SUBJECT: **Entergy Nuclear Operations, Inc.
James A. FitzPatrick Nuclear Power Plant
Docket No. 50-333, License No. DPR-59
License Renewal Application, Amendment 12**

**RAI section 4.3.1, Class 1 Fatigue
SIR-07-084-NPS, Rev. 1**

SUBJECT: SI Response to NRC Requests for Additional Information at Fitzpatrick

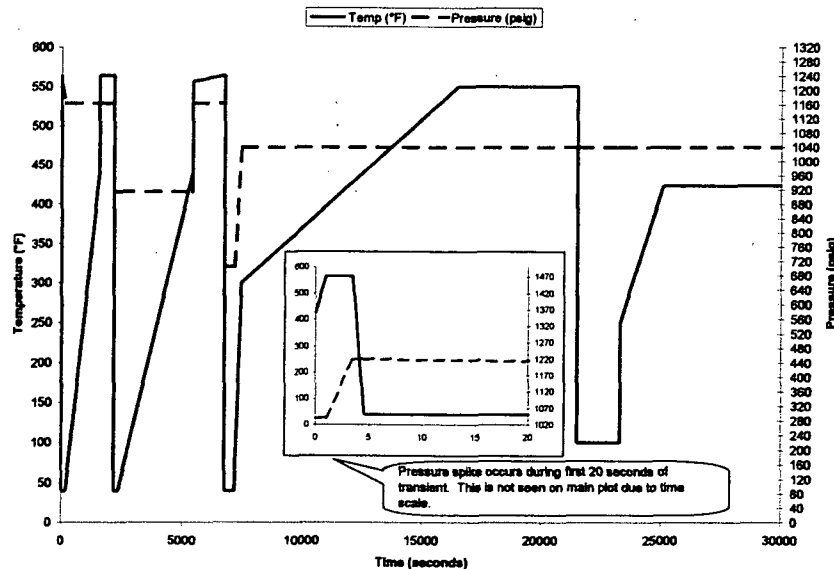
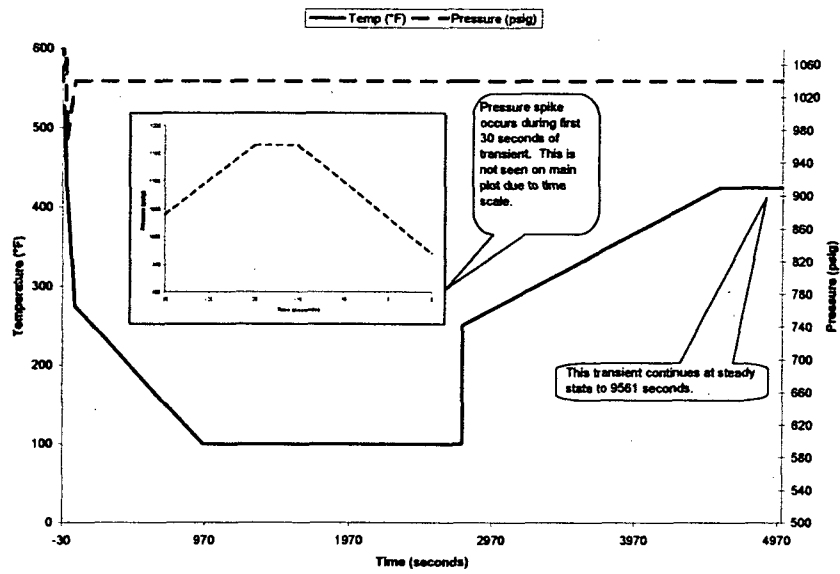
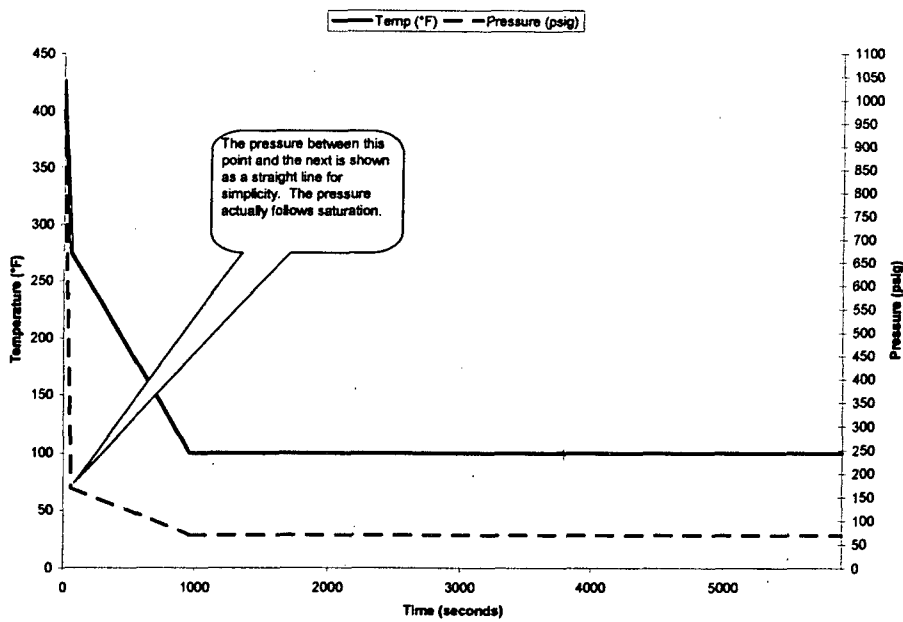
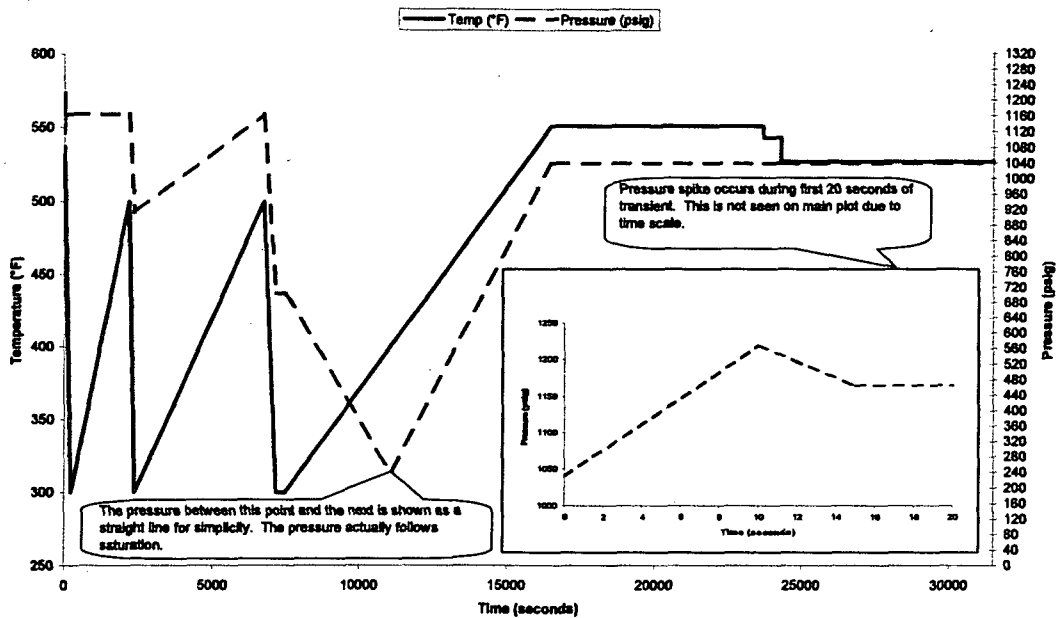
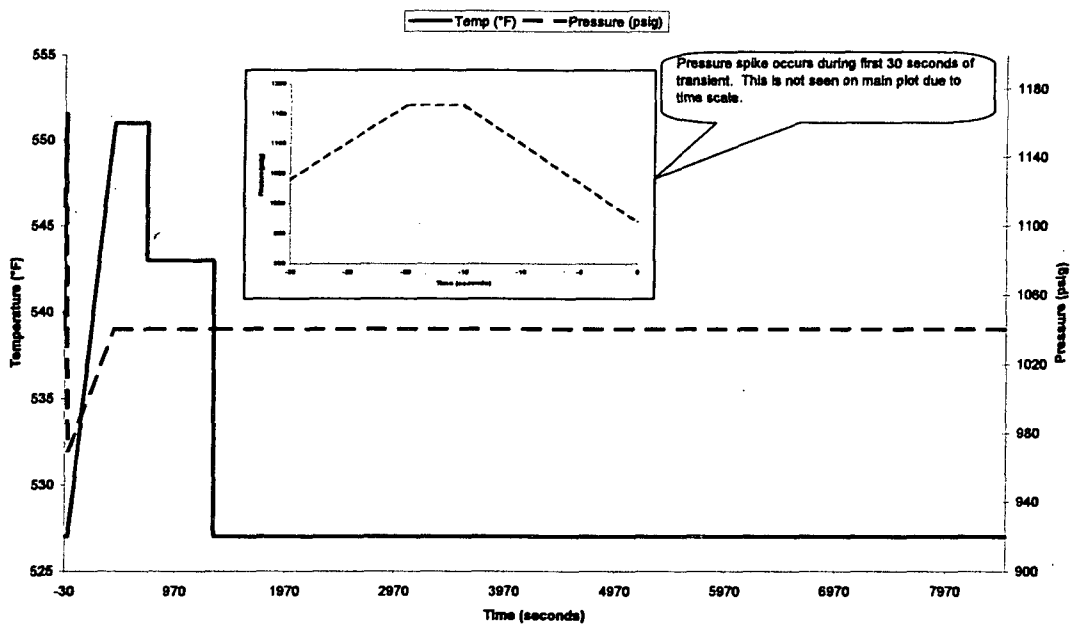
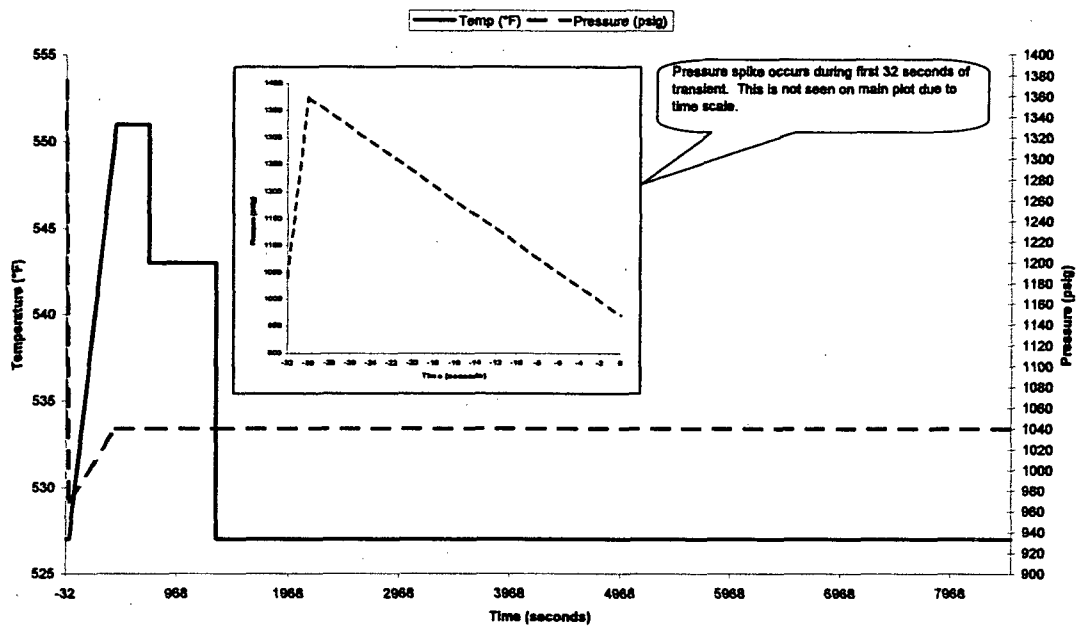
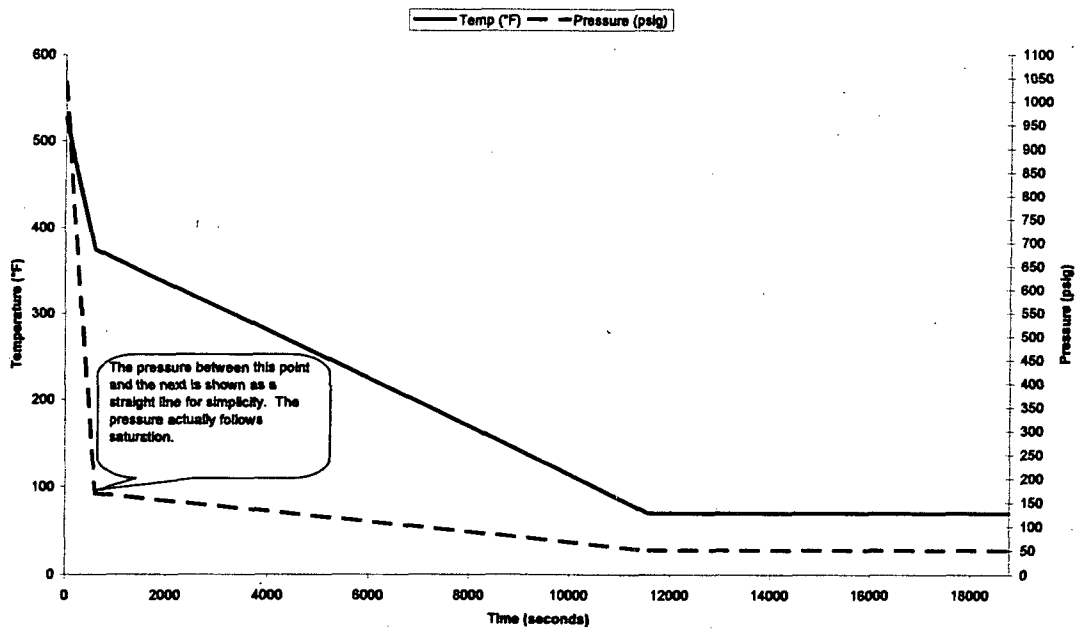
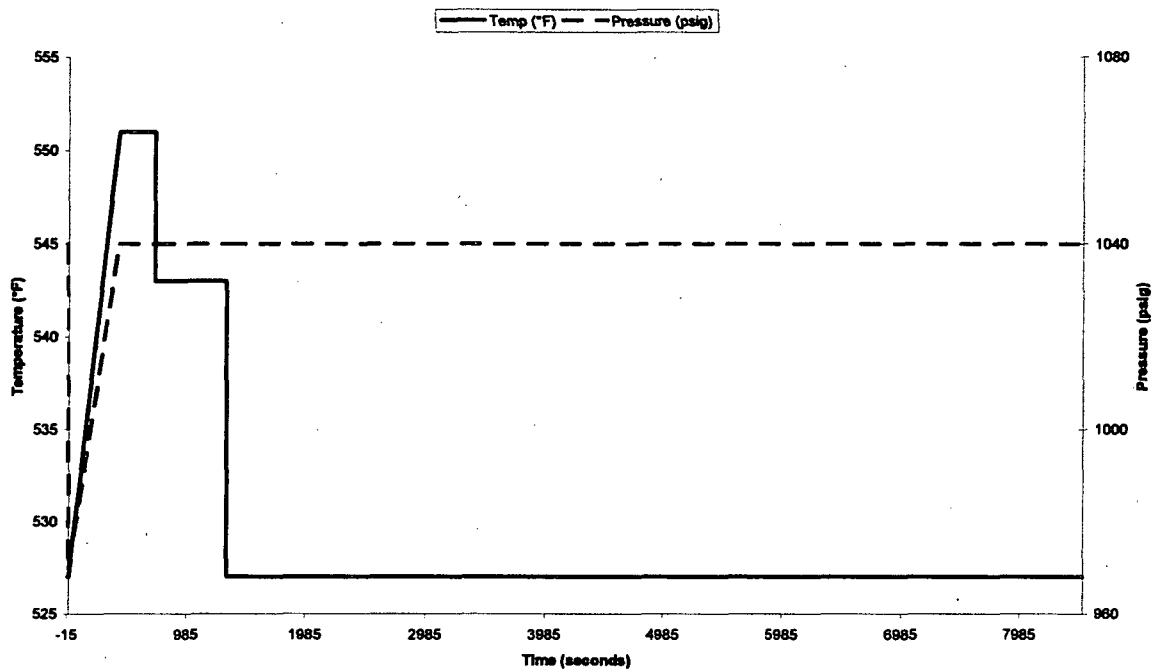
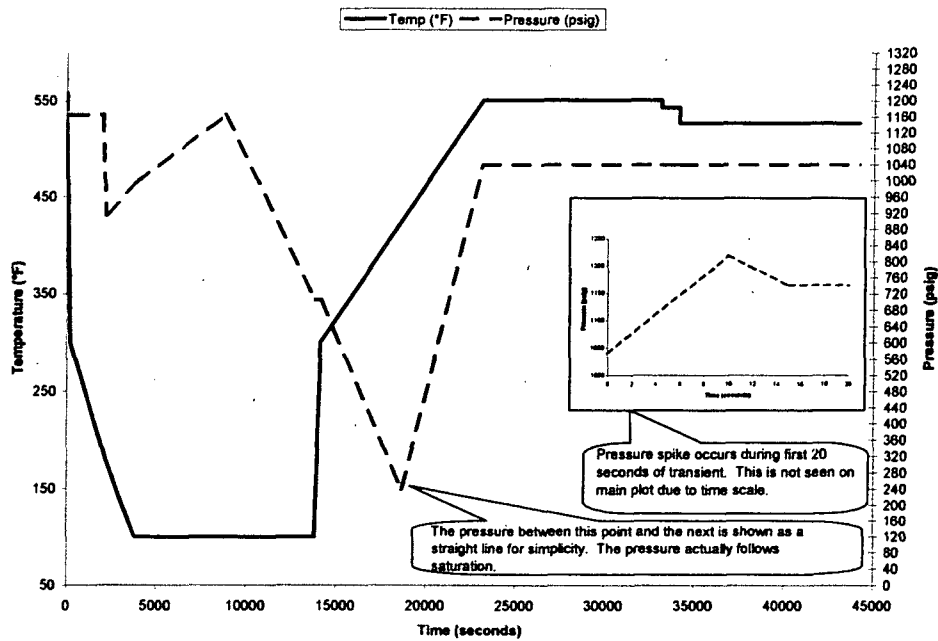
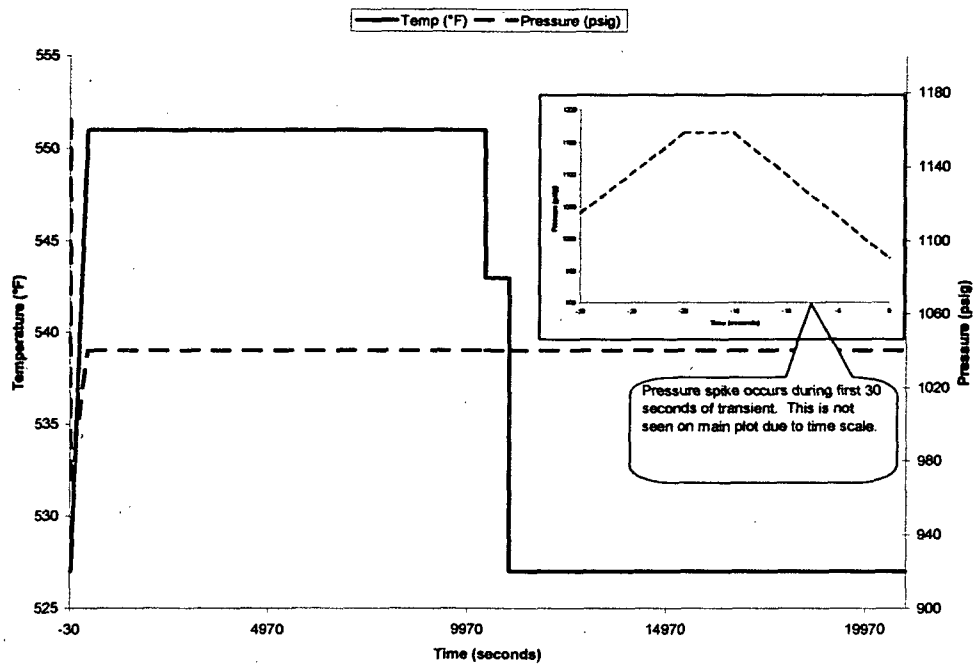
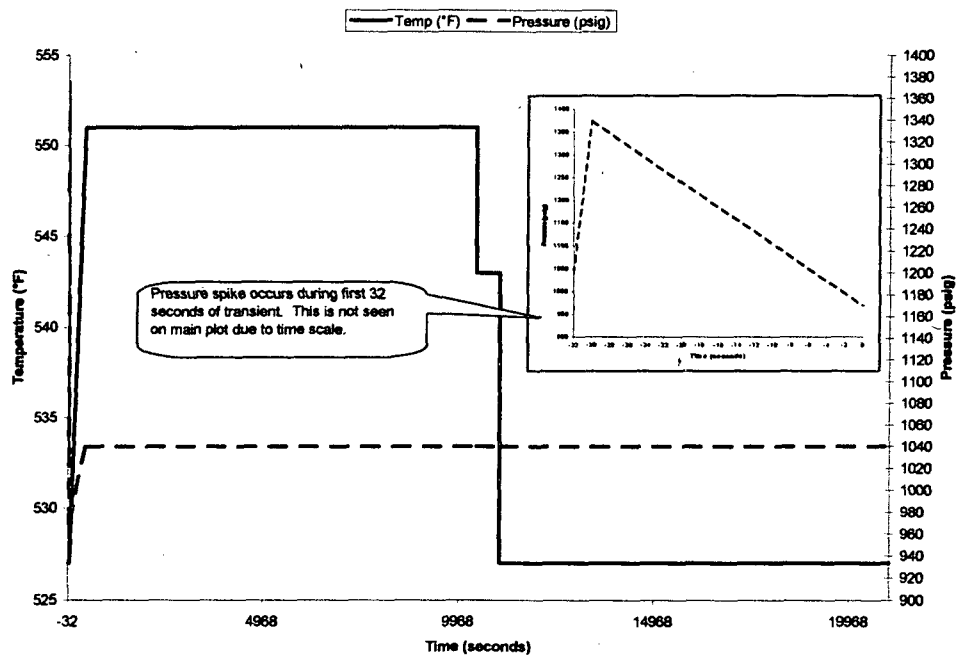
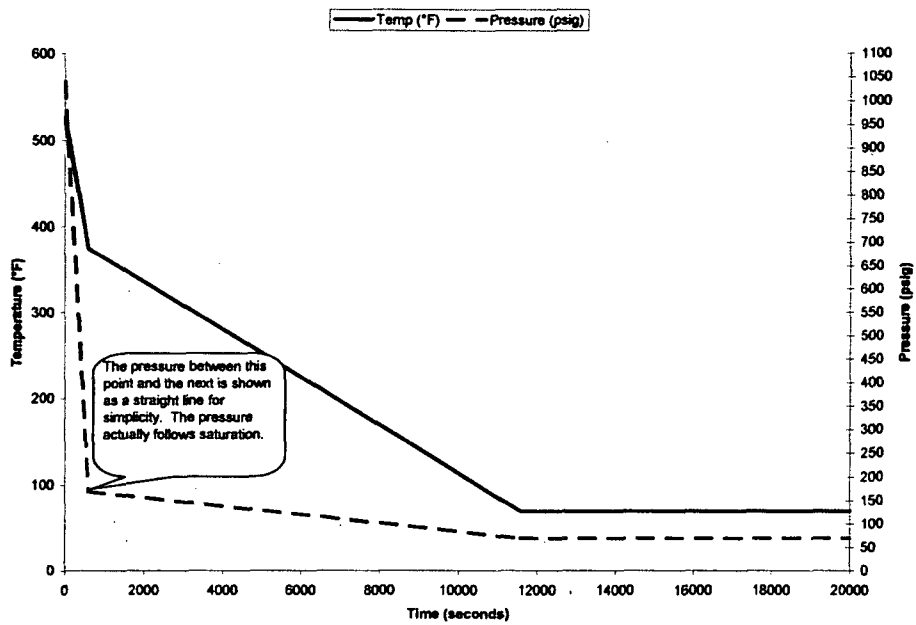
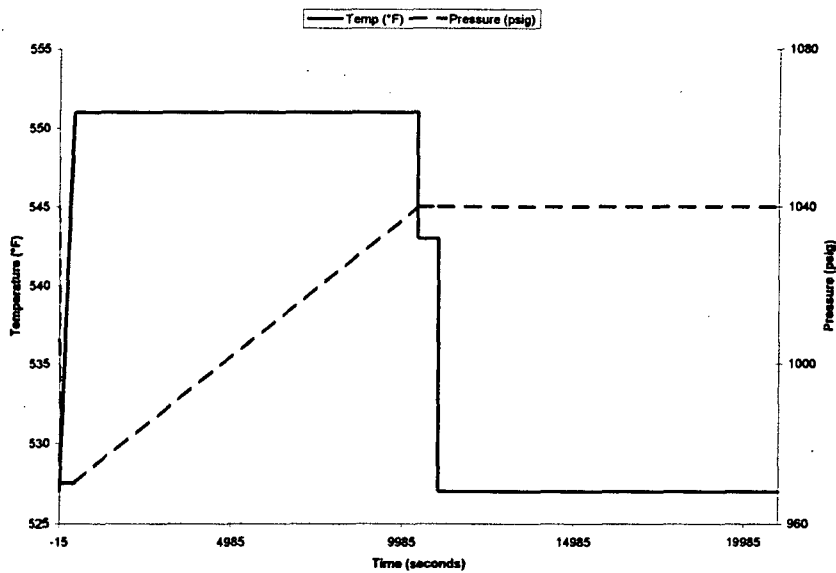
In the GE stress report, GE also mentioned that the change in ΔT associated with these 12 unidentified transients was approximately 330°F. The staff requests the following additional information:

The pressure-temperature data is obtained from the original thermal cycle diagrams [1, 17] for JAFNPP and was modified for power uprate, according to References [9, 18]. The evaluation used the governing stress analyses for the closure bolts as a basis to estimate fatigue usage. The remaining three components (recirculation inlet nozzle, feedwater nozzle and CRD penetrations) were reanalyzed using finite element methods. These transients are defined in the SIA evaluation [19, 20, 21]. Figures C-1 through C-3 identify the Scram transients used in the SIA calculations for the feedwater nozzle. Figures C-4 through C-8 identify the Scram transients used in the SIA calculations for the recirculation inlet nozzle. Figures C-9 through C-13 identify the Scram transients used in the SIA calculations for the control rod drive nozzles. These transient definitions reflect the unique pressure and temperature severity of the design basis Scram event, modified for power uprate conditions, for each evaluated component. The severity is different for each component due to the different thermal regions of the vessel, e.g., the feedwater nozzle is affected by incoming feedwater flow. Consistent with the design basis, the Scram event definitions also include the subsequent return to full power conditions after the initiating Scram.
